BULLETIN BENDIX RADIO

IMPROVING AVC ACTION IN
RA-1 AIRCRAFT RECEIVER

BULLETIN No. M-115

FIGURE 1

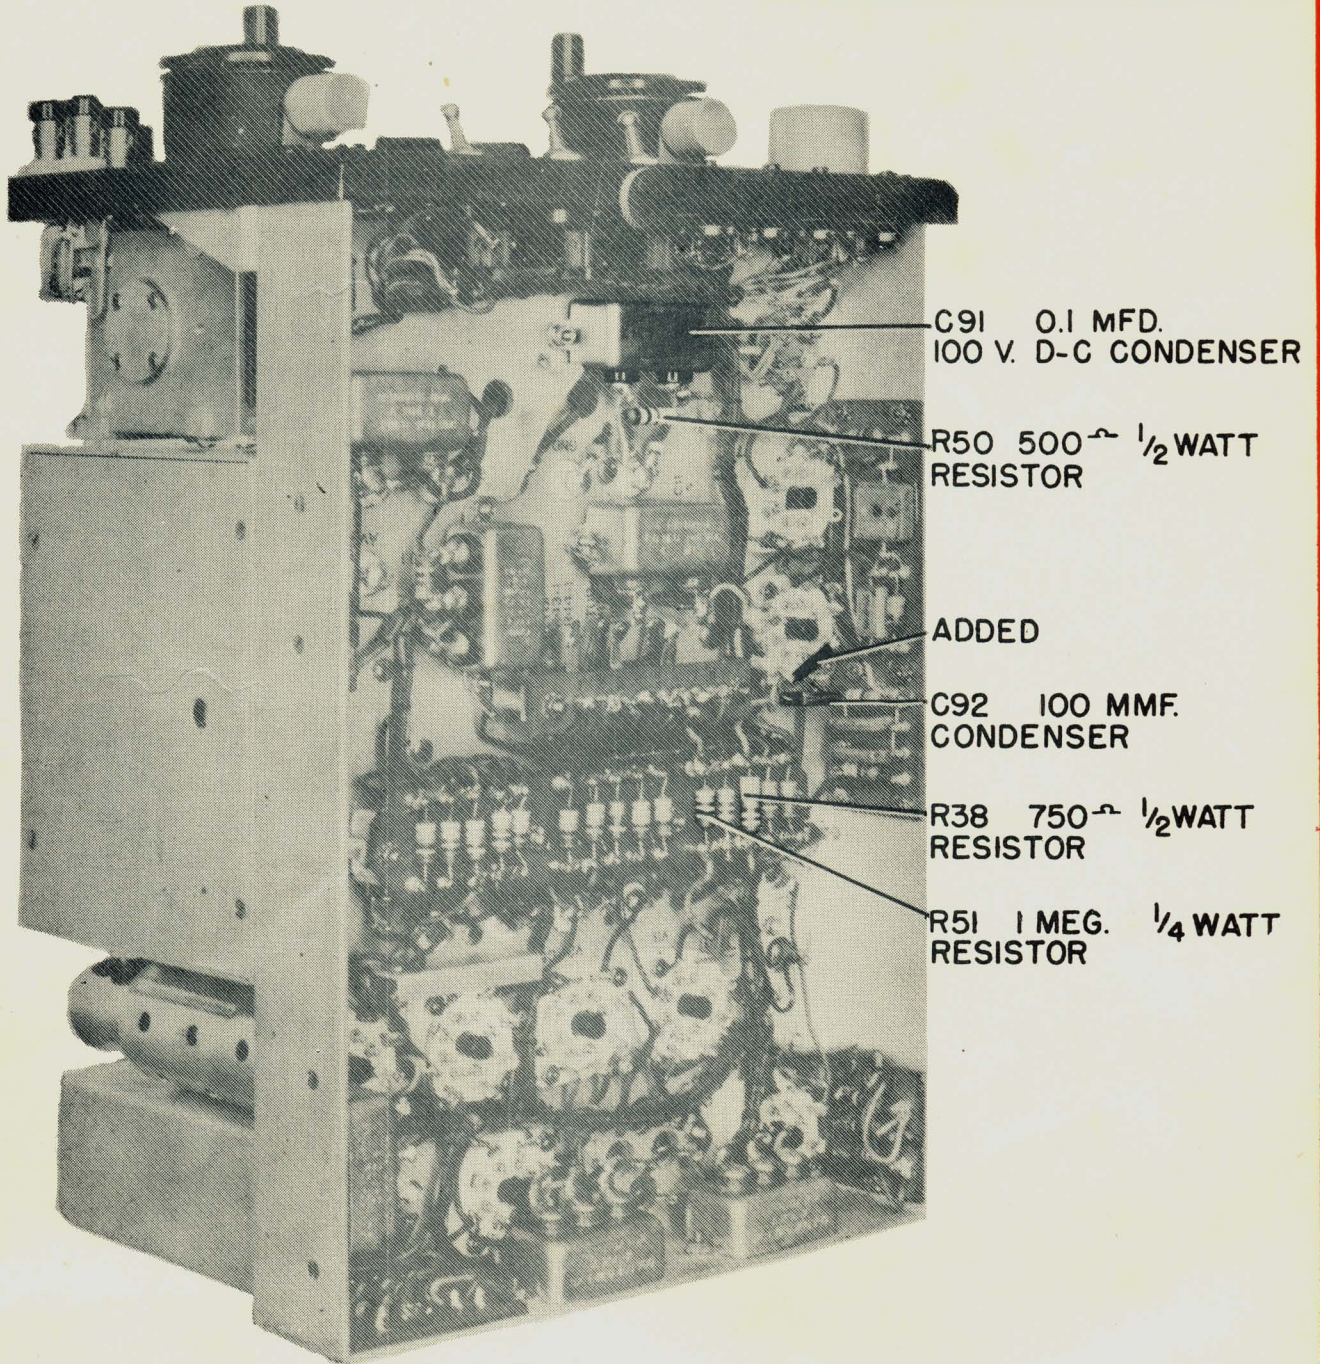
The following changes are to be made on resistor and condenser board assembly AA105053-1. This is the assembly located on the right side of the chassis as shown in Figure 1.

1. Remove ground connection from R24, C65, C67. This is the black wire connected to the top side of R24.
2. Remove ground connection (black wire) from bottom terminal of R37, 1 megohm resistor. (Grid resistor of output tube.)
3. Install jumper wire between bottom terminal of R37 and top terminals of R24, C65, C67.
4. Install C91, 0.1 mfd condenser and R50, 500 ohm resistor as shown

in Figure 1.

FIG. 2 SCHEMATIC DIAGRAM

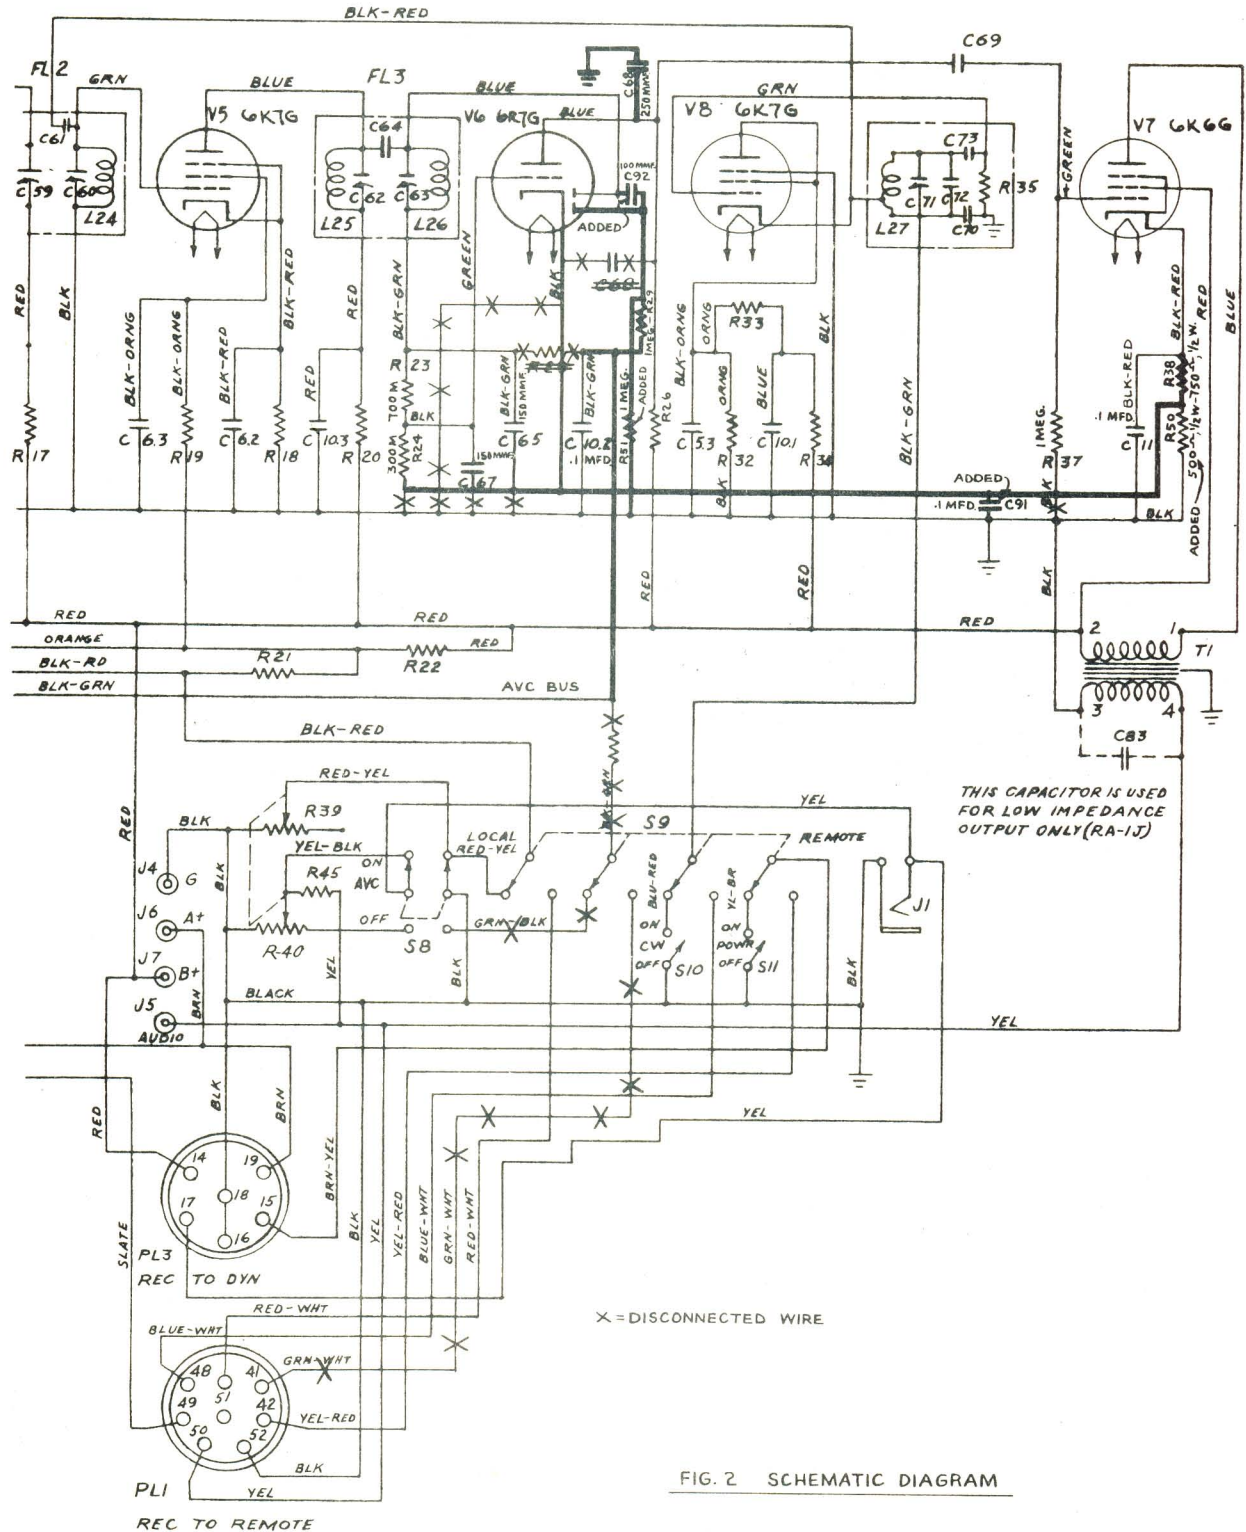
1. Replace R30 (fourth resistor from end of assembly on right side of chassis) with R51, .1 megohm resistor.
2. Remove jumper wire between R51 and R29 terminals; add ground connection from ground lug near V2 and terminal of R51.
3. Install jumper wire between R51 and R29 terminal facing front of set.
4. Remove wire (BK-W) from R51 and cut it off near the cable. Also remove wire (G-W) from pin #41 of PL-1.
5. Remove R38, 750 ohm resistor from C11 and install it between unused terminals on terminal board between R32 and R29. These are the second and third resistors.

Install 100 mmf condenser, C92, on socket of V6 (6R7G) as shown. Remove jumper wires between pin 1 and 8 between 4 and 5. Remove black and green wire from lug marked DR of FL-3 (third IF transformer) and cut off near cable. Also remove green and black wire from AVC switch and cut off near cable. The AVC switch now controls only the ganged RF and audio potentiometers. In AVC ON position, the audio section functions and in AVC OFF position, the RF section functions to control volume. Delayed AVC is present in either position of the AVC switch.

FIGURE 3

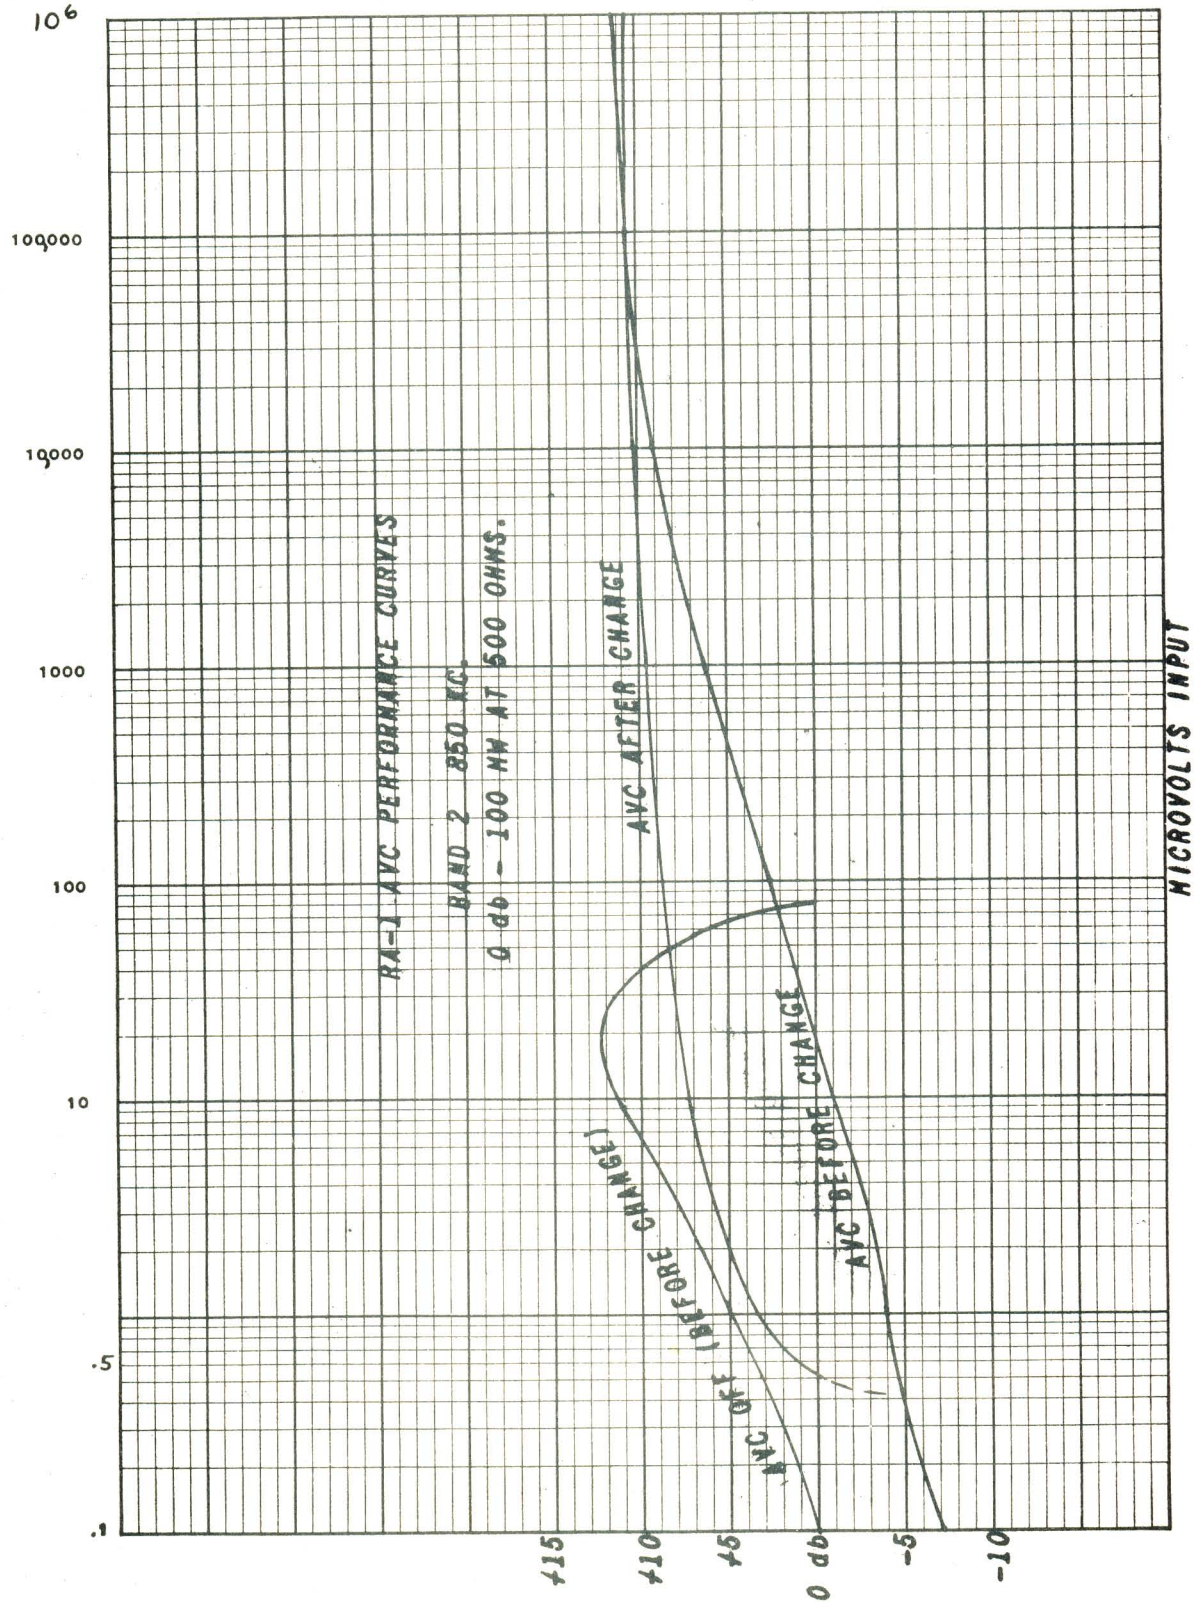
Figure 3 illustrates the AVC control action before and after the changes described herein. These changes have been incorporated in all RA-1 receivers manufactured after May 1, 1944.
